Eusebio Sporting (Bangladesh) Limited

8 February 2024

2. Observations

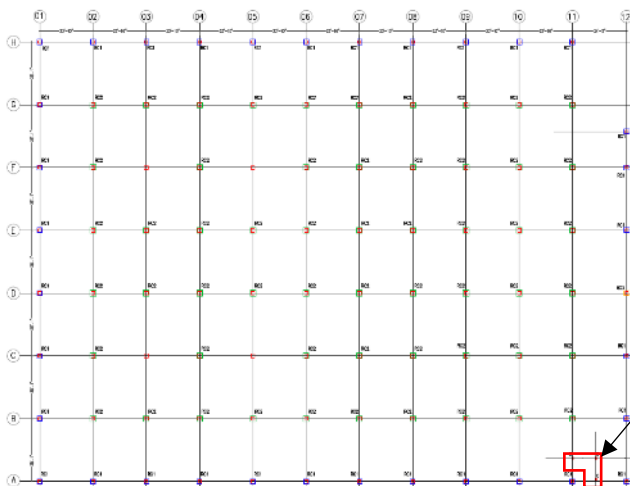
Observation 1: C-type column not considered in design report. (Building 1)

C1 column schedule

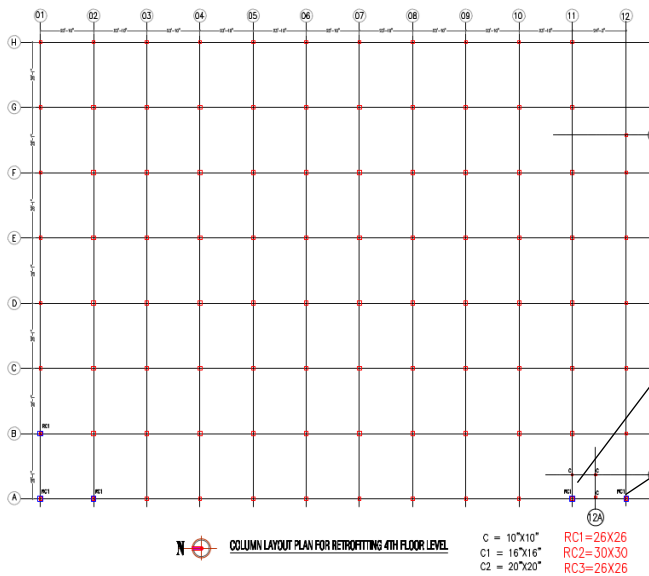
Description: A set of design reports was found on site. As per recommendation of design report remediation was required for foundation, column, and beam. The factory had carried out all remedial works as per retrofitting drawing in 2017. But C type column (250x250 mm) was not considered in the design report. Also, during inspection an adequate amount of retrofitting material test report was not available. The building engineer is required to submit the design documents to the RSC for further review to justify the capacity of foundation, column, and beam & slab against the lateral & vertical loading. Also, verify the retrofitting material strength either from cylinder test report or by taking cores from retrofitted member.

4th floor level column layout plan for retrofitting

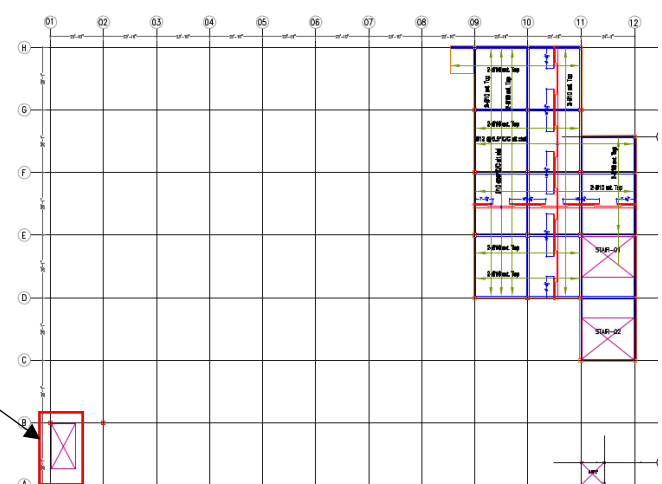
Description: During inspection a few mismatches were found in retrofitting drawing and as built drawing which are given below.

- Marked two columns were not retrofitted at 4th floor level. However, the corner column was constructed up to 3rd floor level, but other column was constructed up to 4th floor level but not retrofitted.
- Also, RC overhead water tank details were found missing in structural drawing.

The building engineer is required to survey the full structure and update the retrofitting drawing, as built drawing, and design report accordingly.

Dampness on stair roof slab

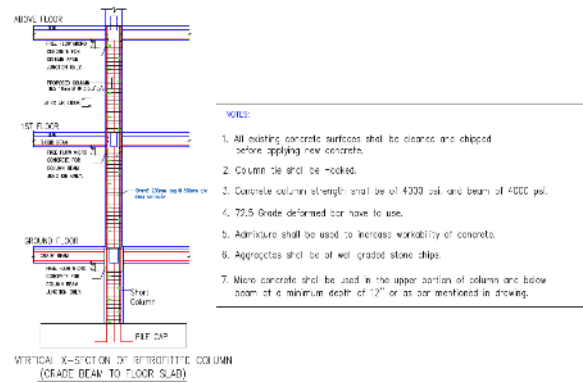
Description: Dampness and brick wall cracks were found at several locations. The building engineer is required to identify the reason for the dampness and crack on brick wall. Prepare an investigation report with the necessary repair method. Repair the crack as per the crack investigation report.

Observation 5: Dampness on column and brick wall. (Building 2)

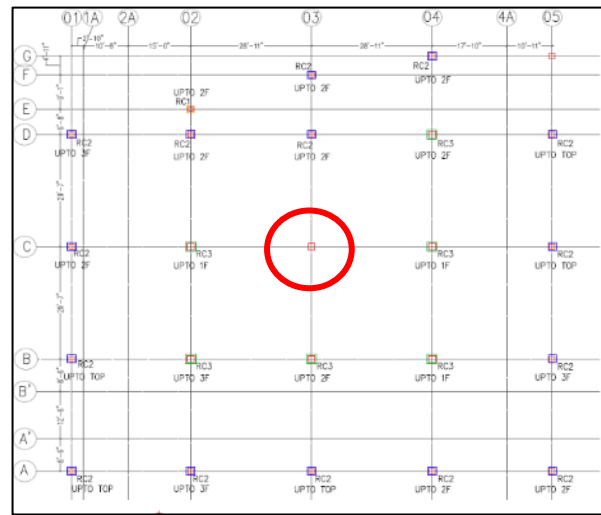
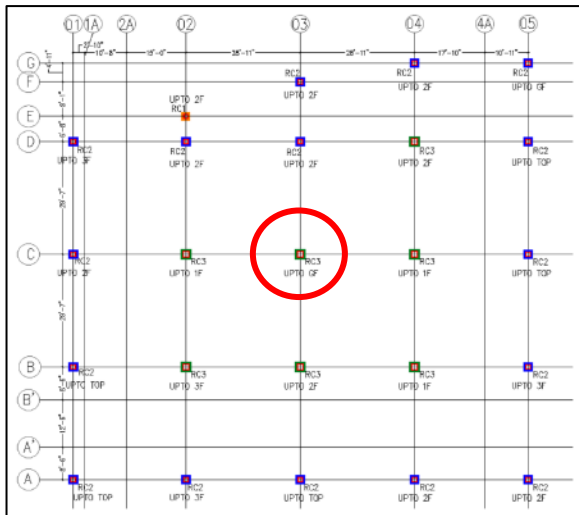
Description: Dampness were found at several locations. The building engineer is required to identify the reason for the dampness and prepare an investigation report with the necessary repair method. Repair the dampness as per the investigation report.

Ground floor column layout plan for retrofitting

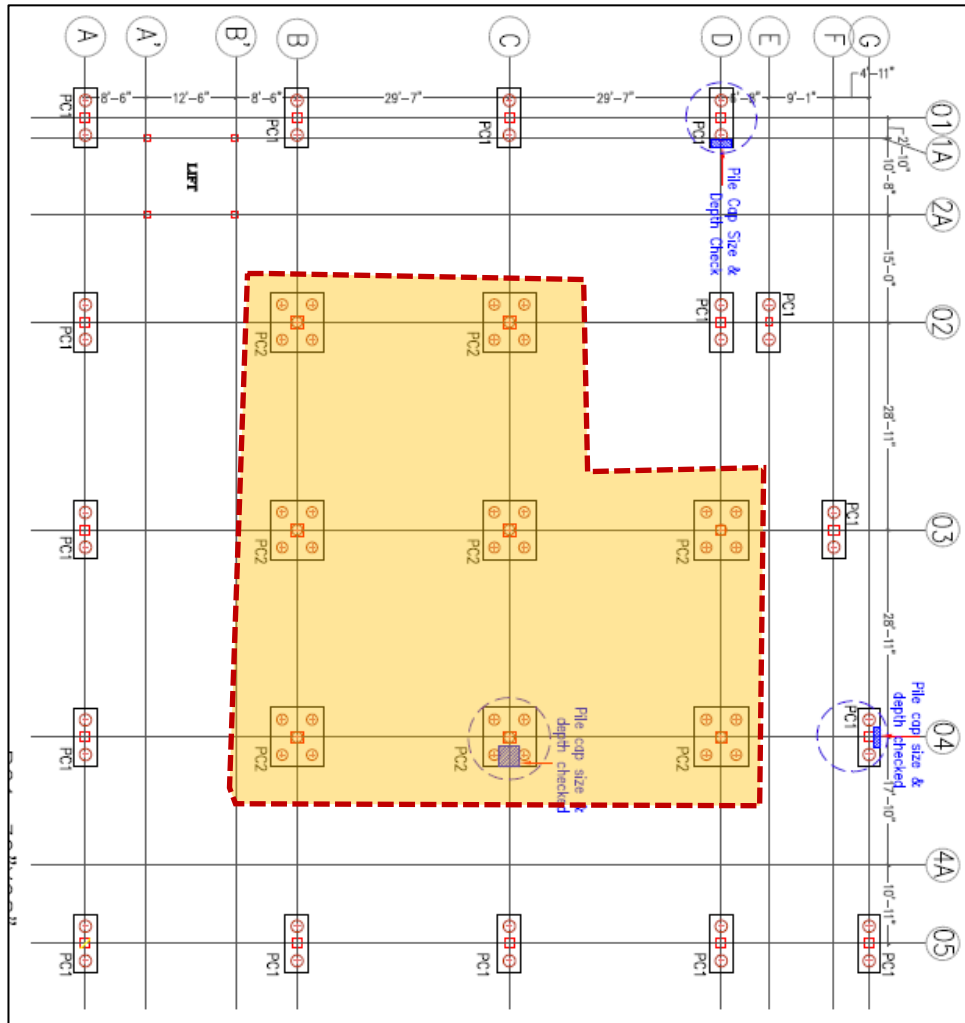
Description: The marked column has been retrofitted only on ground floor level. The cursory calculation indicates that stress in the marked column of Grid (C-3) exceeds the normal design limit considering floor live load of 6 kPa for storage & 3 Kpa for canteen, roof live load of 1.5 kPa, and concrete strength of 13.8 MPa. The building engineer is required to review the design, loads, and column stresses for the marked columns based on in-situ material strength.

Observation 08: Storage live load limit does not comply with BNBC requirement. (Building-3: Store and Dining Building)

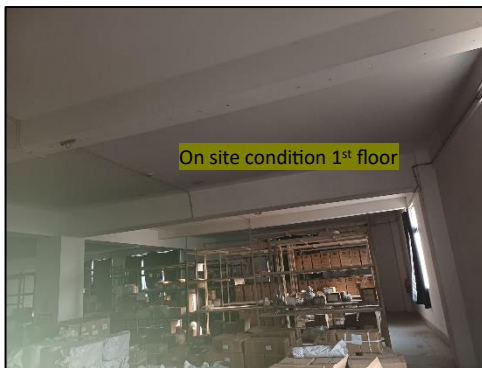
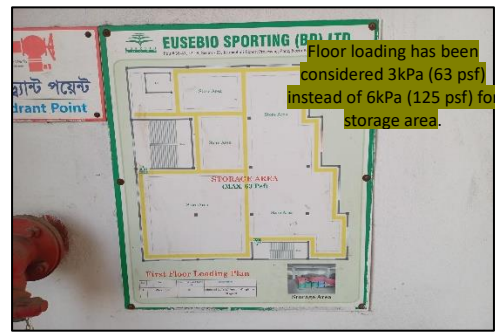
Description: As per BNBC, 6 kPa is required to consider as floor loading for the light storage facilities. During inspection, the load plan was found posted considering (63 psf) 3kPa at storage area. The Building Engineer is required to update the storage live load limit as per BNBC requirement, revise the structural analysis & design report accordingly.

Inadequate joint of beam

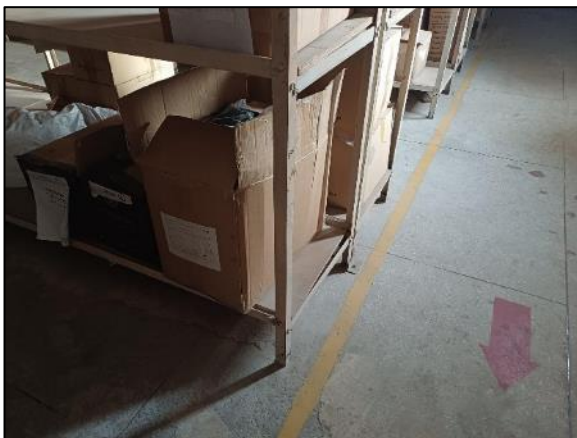
Description: During inspection, marked joints appeared to be inadequate. The building engineer is required to check the connections adequacy and load path and suggest suitable remedial method if required.

Stressed pile in foundation layout

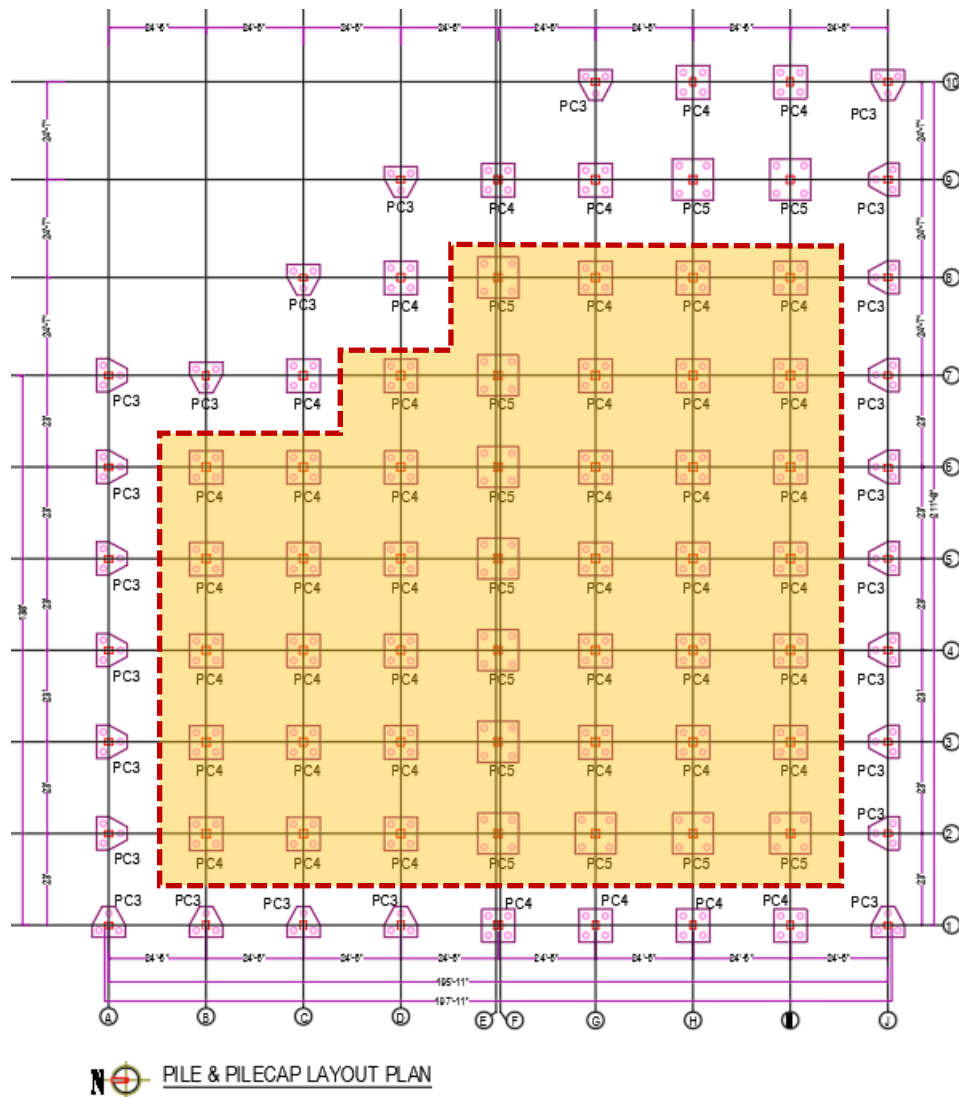
Description: cursory calculation indicates that factor of safety (FoS) of some pile foundations is below the allowable limit considering the floor live load 6 kPa for 1st, 4th and 5th floor, 3 kPa for 2nd and 3rd floor, 1.5 kPa for roof, super imposed load from overhead water tank and ultimate pile capacity 142.65 Ton. Building engineer is required to review the design, loads and foundation stresses and prepare a remediation plan.

MATERIALS STRENGTH CONSIDERATION

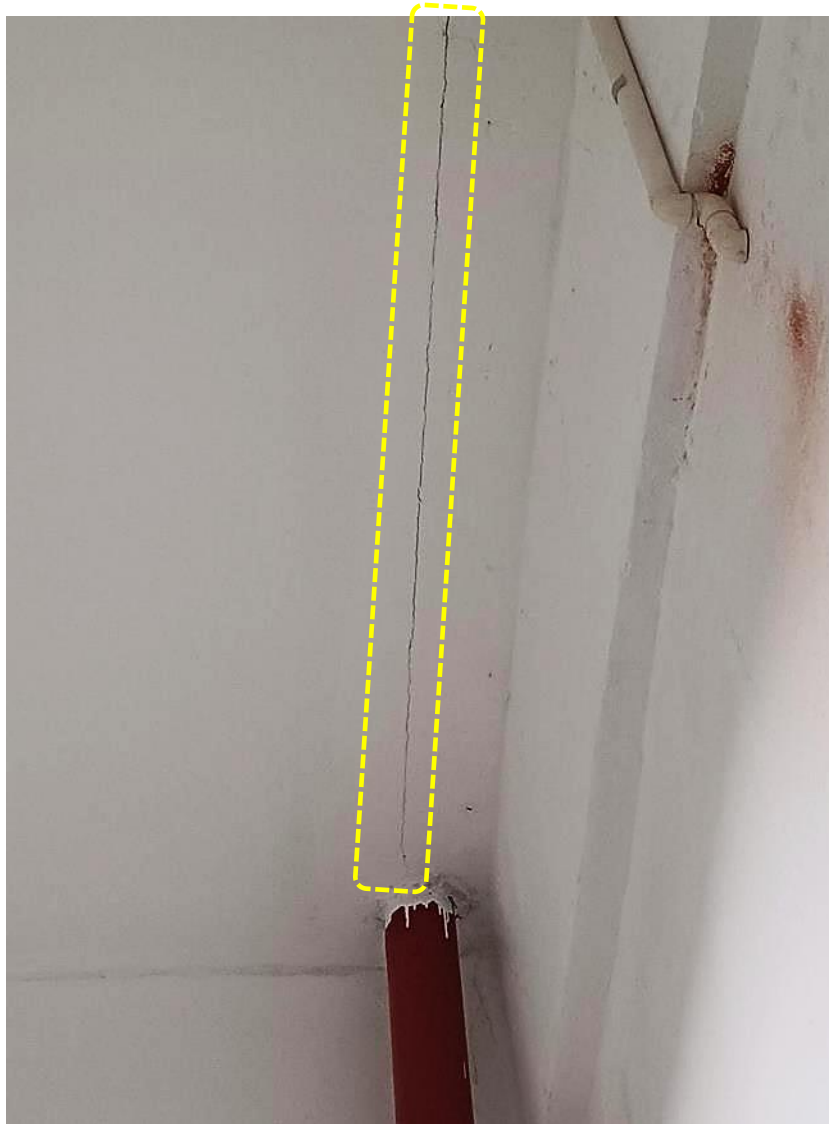
- Description:** In the design report, rebar strength is considered 500 MPa but no rebar test report was provided. Building engineer is required to provide rebar test report for 500 MPa and update the analysis & design report if required.

Observation 20: Crack on brick wall. (Building-5)

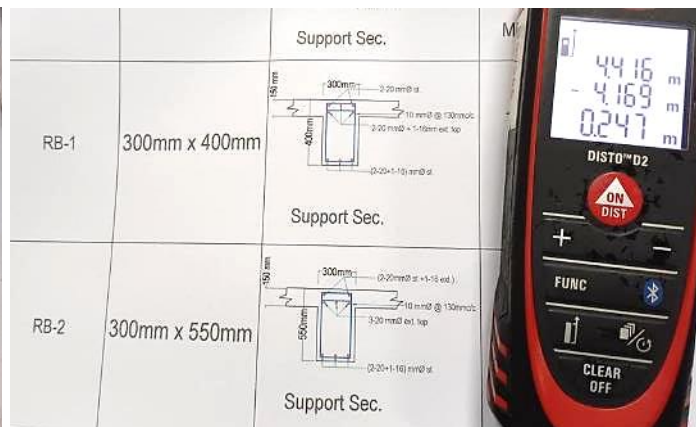
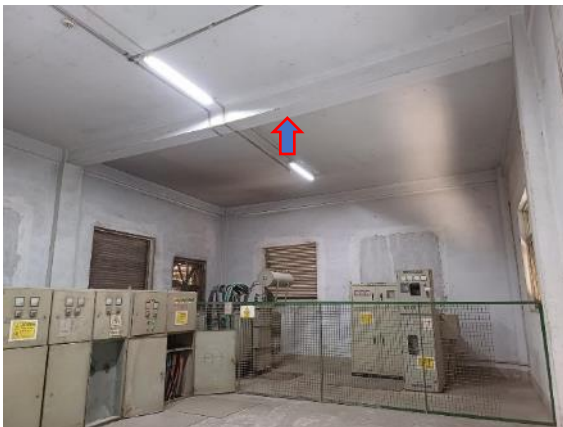
Description: Crack was found at several locations in brick wall. The building engineer is required to identify the reason for the crack in all locations of the building and prepare an investigation report with the necessary repair method. The factory is required to repair the crack as per the crack investigation report.

Observation-25: Mismatch between drawing and onsite condition (Building-9).

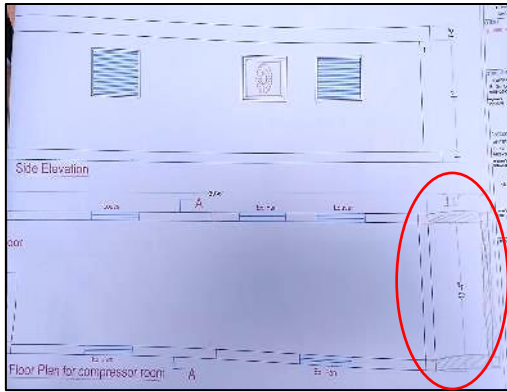
Description: The building dimensions, column and beam sizes do not match the provided drawing. The column size was measured 250 mm instead of 300 mm, down stand beam was measured 200 mm instead of 275 mm and building sizes found difference than the dimensions provided in the drawing. Update as-built drawing.

Extension not shown in drawing

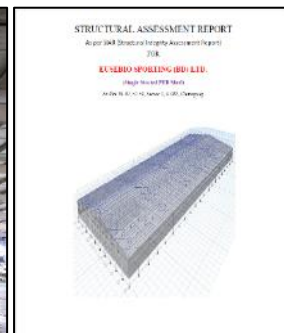
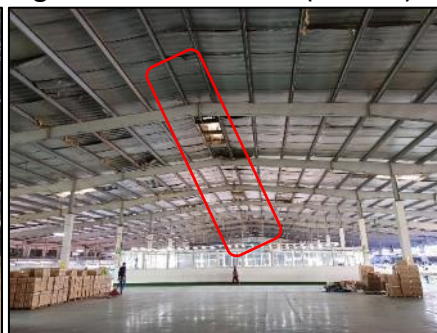
Description: Horizontal expansion of one bay was found onsite which was not reflected in the drawing. Update as-built drawing.

Shed-1

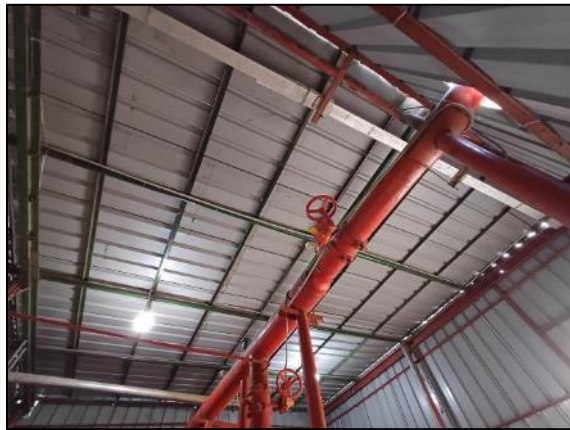
Description: There is no lateral load transfer media along the ridge and internal column line of the steel rafter. A set of design documents was available onsite which is required to be submitted to RSC for detailed review against lateral forces. Revise the design documents based on in-situ material strength and submit to the RSC for review.

Observation-30: Apparent lack of lateral stability. (Shed-2)

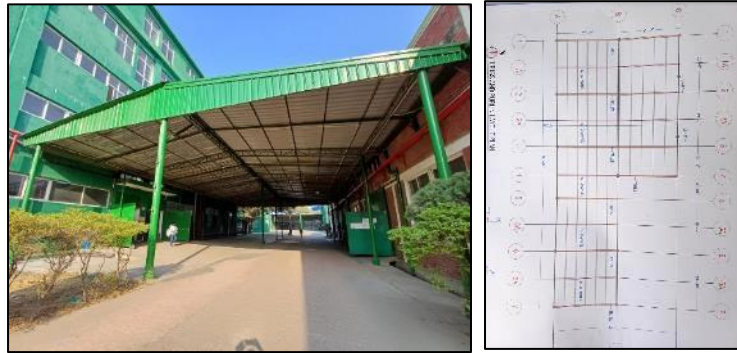
Description: The stability system of the structure is apparently inadequate. Also, the channel shaped steel rafter was found instead of MS pipe. The building engineer is required to survey the structure, prepare as-built drawings, check the stability of the structure and submit the documents to the RSC.
